Historic Preservation Board Staff Report

Author: Anya Grahn, Historic Preservation Planner
Subject: Material Deconstruction and Reconstruction Review
Address: 803 Norfolk Avenue
Project Number: PL-15-02923
Date: November 11, 2016
Type of Item: Administrative – Material Deconstruction and Reconstruction

Address: 803 Norfolk Avenue
Designation: Significant
Applicant: Jim Hewitson (Architect Jon DeGray)
Proposal:
1. Reconstruction of c.1938 corrugated metal garage along Crescent
2. Material Deconstruction of stacked stone retaining walls, historic roof and dormers, chimney, demolition of historic and non-historic foundation elements, historic and non-historic porch elements on the front and side porches, historic doors, replacement of historic and non-historic windows; removal of portions of historic walls in order to accommodate a new addition on the northwest corner of the historic house.

Site Plan showing the location of the existing retaining walls.

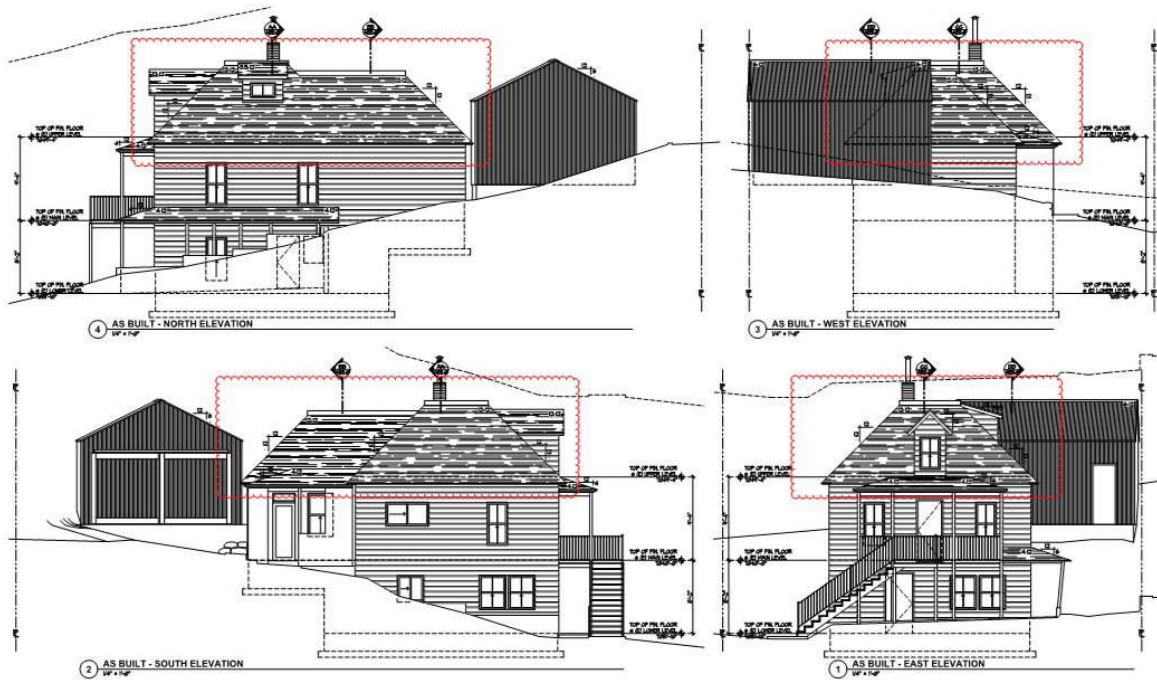
Staff finds that the proposed work to reconstruct the retaining walls mitigates any impact that will occur to the visual character of the neighborhood and any impact to the architectural integrity of the site’s buildings.

Location of new dormers on the reconstructed roof.

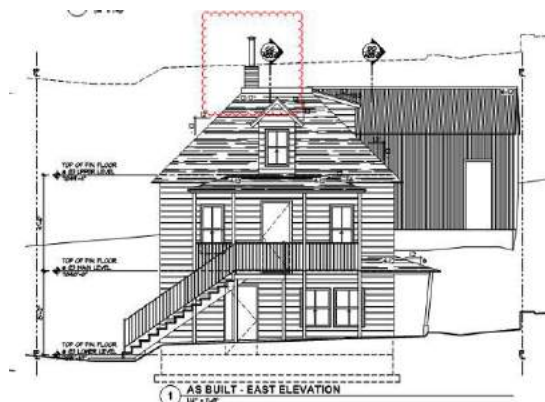
Additionally, the applicant proposes to construct two (2) new shed dormers—one on each side—on the reconstructed roof of the c.1887 addition. The proposed dormers are consistent with the scale of the building. Staff finds that the new dormers are appropriate as they are beyond the midpoint of the historic house and are located toward the rear of the building where they do not detract from the historic façade of the house.

Staff finds that the new dormers are exterior changes that will not damage or destroy the exterior architectural features of the subject property that are compatible with the character of the historic site. Further, the proposed exterior changes shall not damage or destroy the exterior architectural features of the property which are compatible with the character of the historic site. Staff recommends adding Condition of Approval 6, stipulating that the new roof dormers must be a minimum of 6" below the ridge of the historic roof.

6. The new dormers on the north and south sides of the historic west addition will be constructed a minimum of 6 inches below the ridgeline.
7. Where the historic exterior materials cannot be repaired, they will be replaced with materials that match the original in all respects: scale, dimension, texture, profile, material and finish. Prior to removing and replacing historic materials, the applicant shall demonstrate to the Planning Director and Project Planner that the materials are no longer safe and/or serviceable and cannot be repaired to a safe and/or serviceable condition. No historic materials may be disposed of prior to advance approval by the Planning Director and Project Planner.

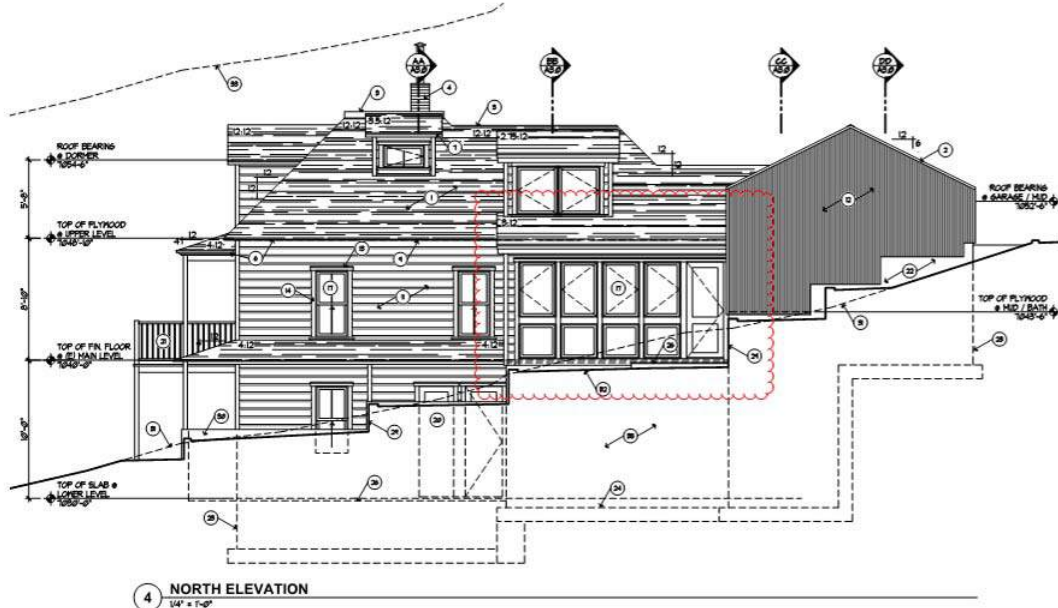
The majority of the original siding is in fair to good condition as it was largely protected beneath the asbestos cement siding. Nevertheless, staff finds that some of the individual siding and trim members will be damaged and deteriorated beyond repair. Staff proposes the following Condition of Approval to address this.

Staff finds that the proposed siding restoration is routine maintenance and does not require Historic Preservation Board Review.

#7. Where the historic exterior materials cannot be repaired, they will be replaced with materials that match the original in all respects: scale, dimension, texture, profile, material and finish. Prior to removing and replacing historic materials, the applicant shall demonstrate to the Planning Director and Project Planner that the materials are no longer safe and/or serviceable and cannot be repaired to a safe and/or serviceable condition. No historic materials may be disposed of prior to advance approval by the Planning Director and Project Planner.

Proposed sunporch addition on the northwest corner of the historic house.

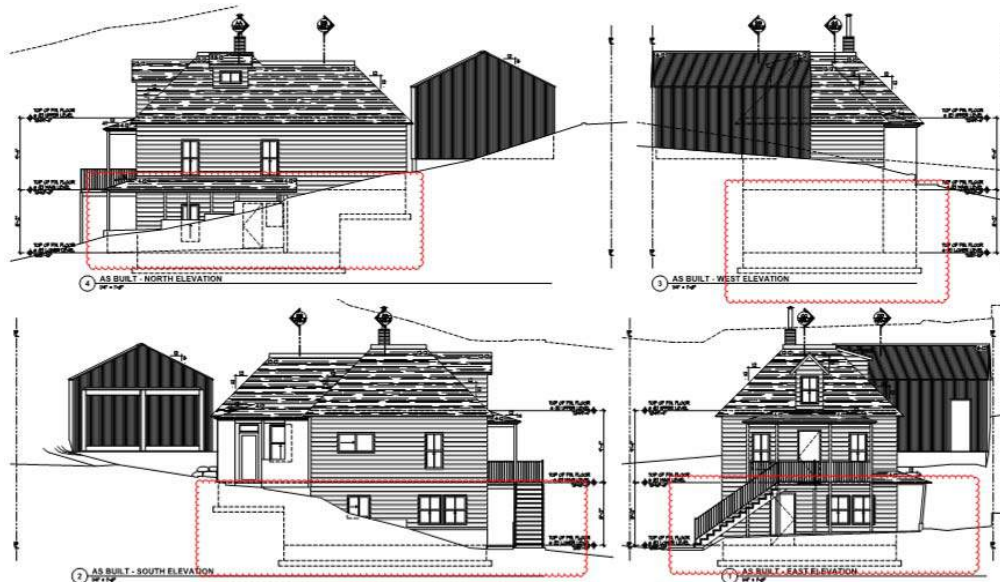
While the new sleeping porch addition is proposed in the same location as the now-lost sleeping porch, it will not be an accurate reconstruction. The new addition will need to comply with current setbacks and the lack of physical and photographic evidence of the original would make an accurate reconstruction difficult. Further, the proposed sleeping porch will reflect the openness of the original but feature glass windows so that the interior can be conditioned space rather than an outdoor room.

Staff finds that the alterations to the exterior siding to accommodate the new sleeping porch addition shall not damage or destroy the exterior architectural features of the subject property which are compatible with the character of the historic site.

Upper level front porch proposed to be reconstructed.

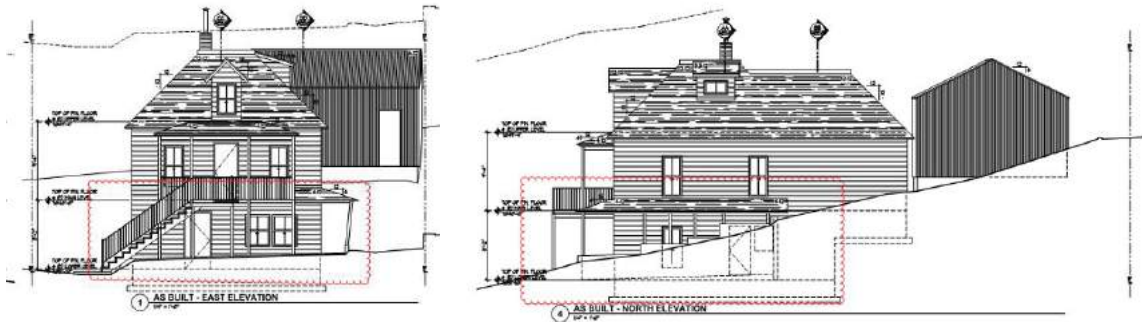
The porch is largely deteriorated. The wood stair structure has deteriorated and the structural members have detached from the original structure. The porch floor shows sign of wood rot and the porch railings and posts are not historic. The applicant proposes to completely reconstruct the porch.

Staff finds that the reconstruction of the porch and the entailed material deconstruction is necessary for the restoration and rehabilitation of the building and the reconstruction of this element.

Proposed location of expanded door opening.

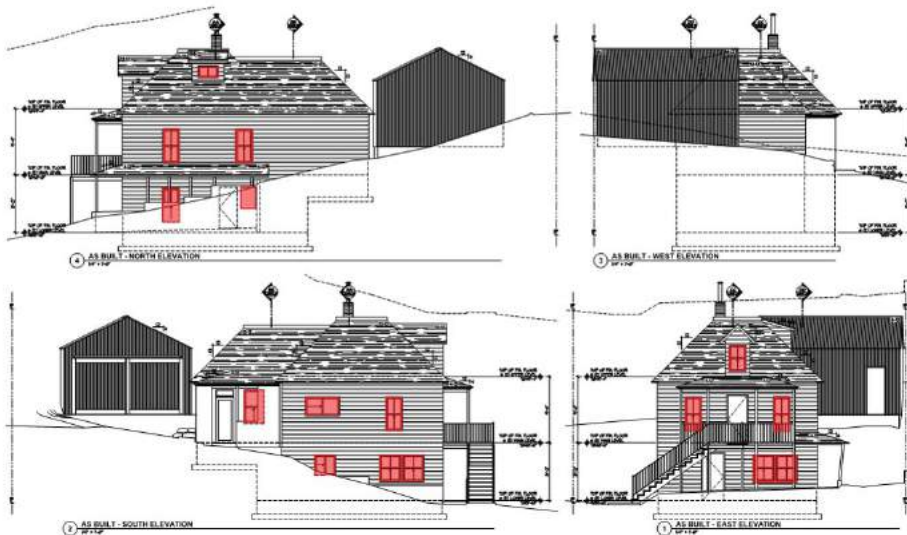
The applicant is proposing to replace all of the doors with new wood doors. The doors on the Norfolk façade will match the historic doors. The door on lower level of the north elevation, below grade, will be expanded to a patio door. Staff finds that this is a minimal change and will not be visible from the primary right-of-way.

Staff finds that the proposed scope of work for material deconstruction mitigates any impacts that will occur to the visual character of the neighborhood and any impacts that will occur to the historical significance of the buildings, structures, or objects located on the property.
